1.2 General Plant Description

The information in this section of the reference ABWR DCD, including all subsections, tables, and figures, is incorporated by reference with the following departures and supplements.

Figure 1.2-1 Site Plan

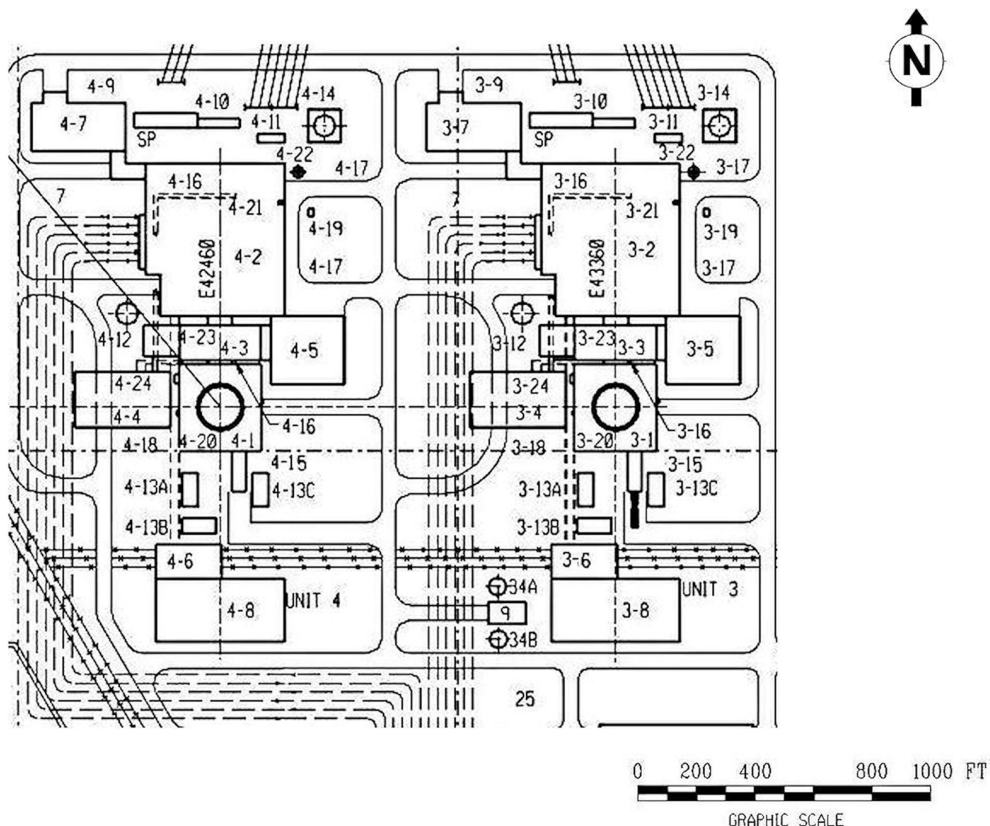
STP DEP 1.1-2 (Figure 1.2-1)

STP 3 & 4 are located on the existing South Texas Project (STP) site. The 12,220 acre site is located in a rural area of south central Matagorda county. STP 3 & 4 are located near the Main Cooling Reservoir which has sufficient capacity to serve as main condenser heat sink. The Colorado River provides makeup water to the Main Cooling Reservoir.
